SUBJECT: MCGUIRE NUCLEAR STATION, UNITS 1 AND 2 - STAFF ASSESSMENT OF INFORMATION PROVIDED PURSUANT TO TITLE 10 OF THE *CODE OF FEDERAL REGULATIONS* PART 50, SECTION 50.54(f), SEISMIC HAZARD REEVALUATIONS FOR RECOMMENDATION 2.1 OF THE NEAR-TERM TASK FORCE REVIEW OF INSIGHTS FROM THE FUKUSHIMA DAI-ICHI ACCIDENT (TAC NOS. MF3689 AND MF3690)

STAFF ASSESSMENT BY THE OFFICE OF NUCLEAR REACTOR REGULATION

RELATED TO SEISMIC HAZARD AND SCREENING REPORT

WMCGUIRE NUCLEAR STATION, UNITS 1 AND 2

Figure 3.3-3 Plot Comparing the Staff's and the Licensee's Mean Control Point Hazard Curves at a Variety of Frequencies for the McGuire site

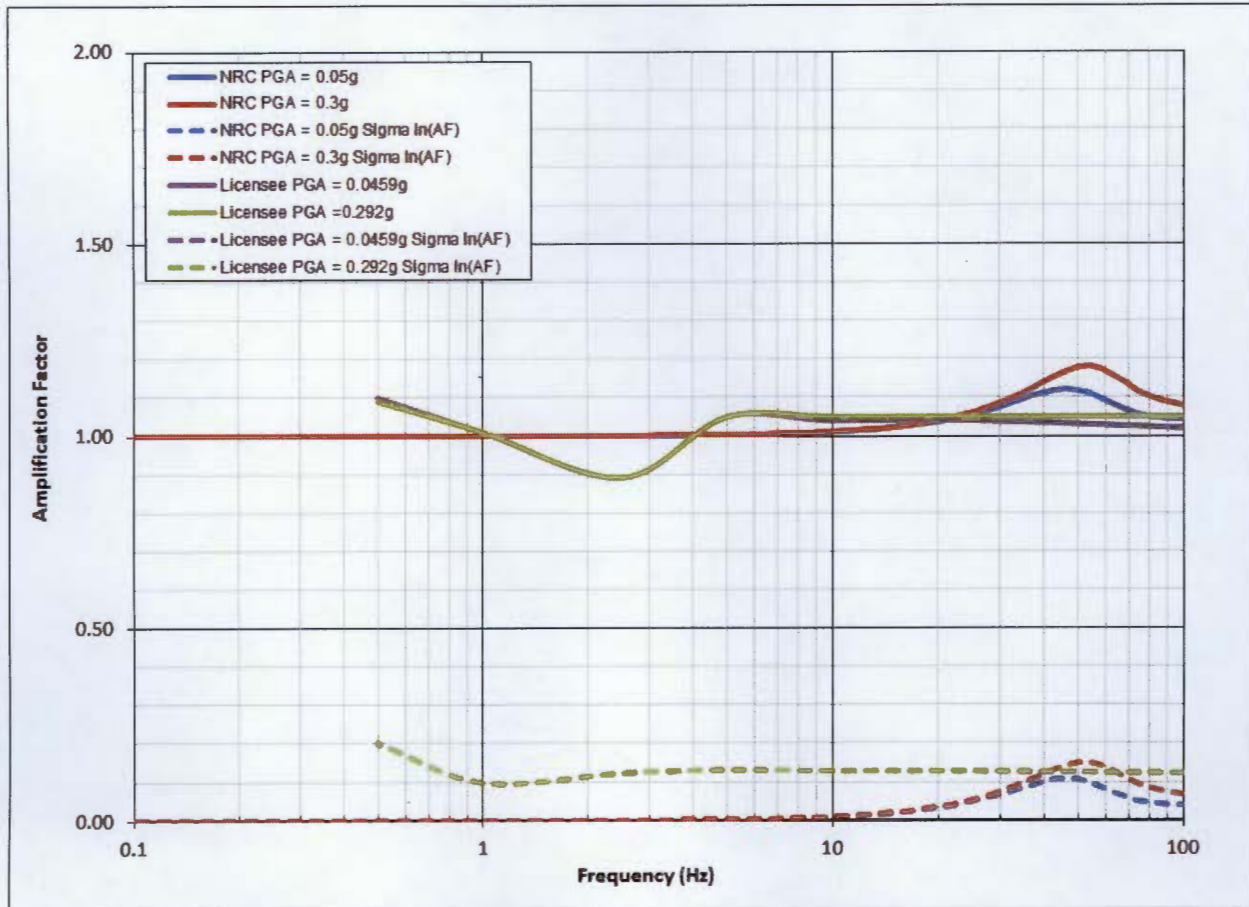
Overall, the licensee's approach to modeling the subsurface rock properties and to modeling their uncertainty results in similar amplification factors as those developed by the NRC staff. As shown in Figure 3.3-3 of this assessment, the NRC staff notes these differences in the site response do not have a large impact on the control point seismic hazard curves or the resulting GMRS, as discussed below. Appendix B of the SPID provides guidance for performing site response analyses, including capturing the uncertainty for sites with less subsurface data; however, the guidance is neither entirely prescriptive nor comprehensive. As such, various approaches in performing site response analyses, including the modeling of uncertainty, are acceptable for the 50.54(f) response.

Figure 3.4-1 Comparison of the Staff's GMRS with Licensee's GMRS and the SSE for the McGuire site

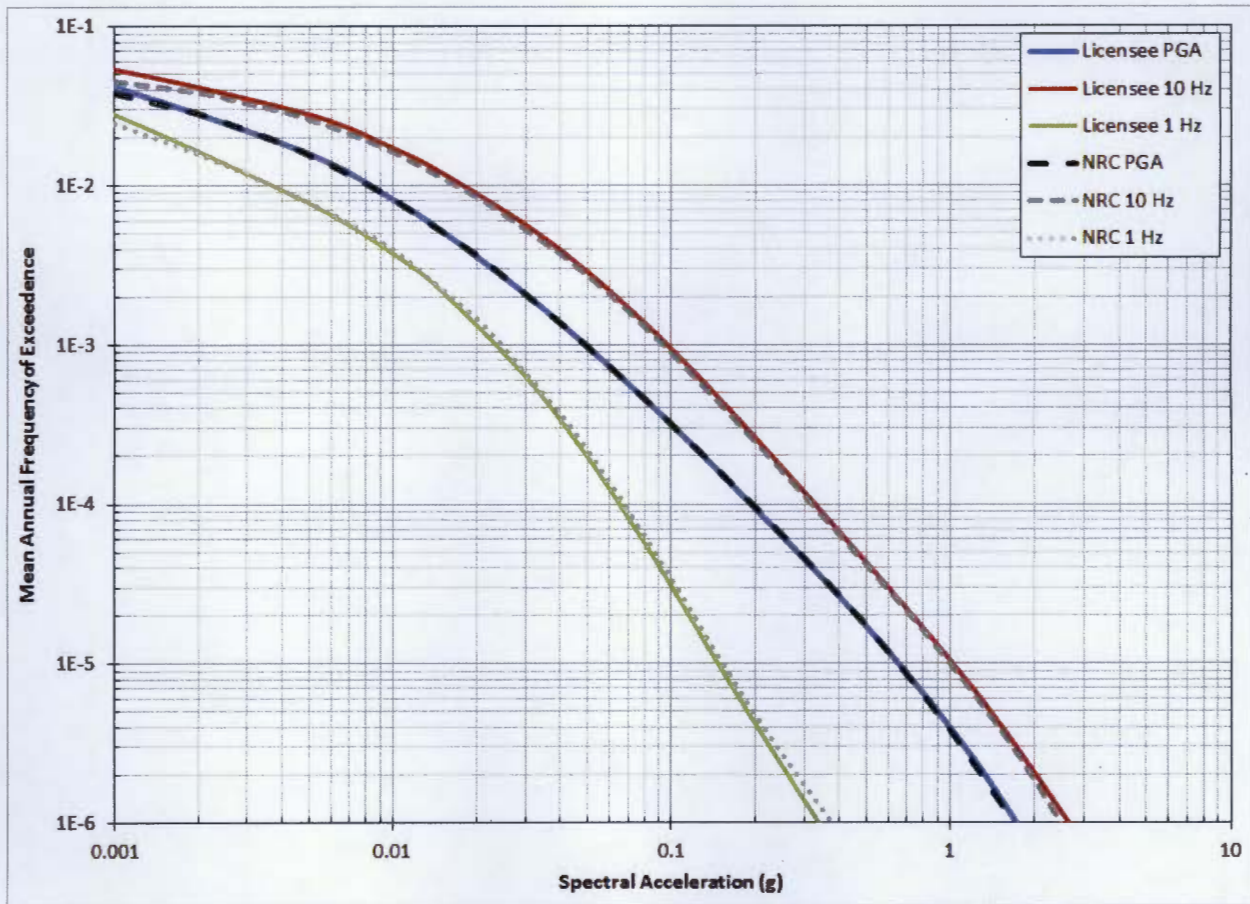
The NRC staff independently calculated the 10^{-4} and 10^{-5} UHRs using the results of its confirmatory PSHA and site response analyses, as described in Sections 3.2 and 3.3 of this staff assessment, respectively. Figure 3.4-1 of this assessment shows a comparison of the GMRS determined by the licensee to that determined by the NRC staff.

As shown in Figure 3.4-1, the licensee's GMRS shape is generally similar to that calculated by the NRC staff at frequencies less than 45 Hz. However, the NRC staff's confirmatory GMRS is somewhat higher than the licensee's at frequencies above 45 Hz. As described above in Section 3.3, the NRC staff concludes that these minor differences over the higher frequency range are primarily due to the differences in the site response analyses performed by the licensee and staff. The NRC staff concludes that the differences between the two GMRS are acceptable for this application because the licensee followed the guidance provided in the SPID with respect to both the PSHA and site response analysis for the McGuire site.

The staff confirms that the licensee used the present-day guidance and methodology outlined in RG 1.208 and the SPID to calculate the horizontal GMRS, as requested in the 50.54(f) letter. The NRC staff performed both a PSHA and site response confirmatory analysis, and achieved results consistent with the licensee's horizontal GMRS. As such, the NRC staff concludes that the GMRS determined by the licensee adequately characterizes the reevaluated hazard for the McGuire site. Therefore, this GMRS is suitable for use in subsequent evaluations and confirmations, as needed, for the response to the 50.54(f) letter.
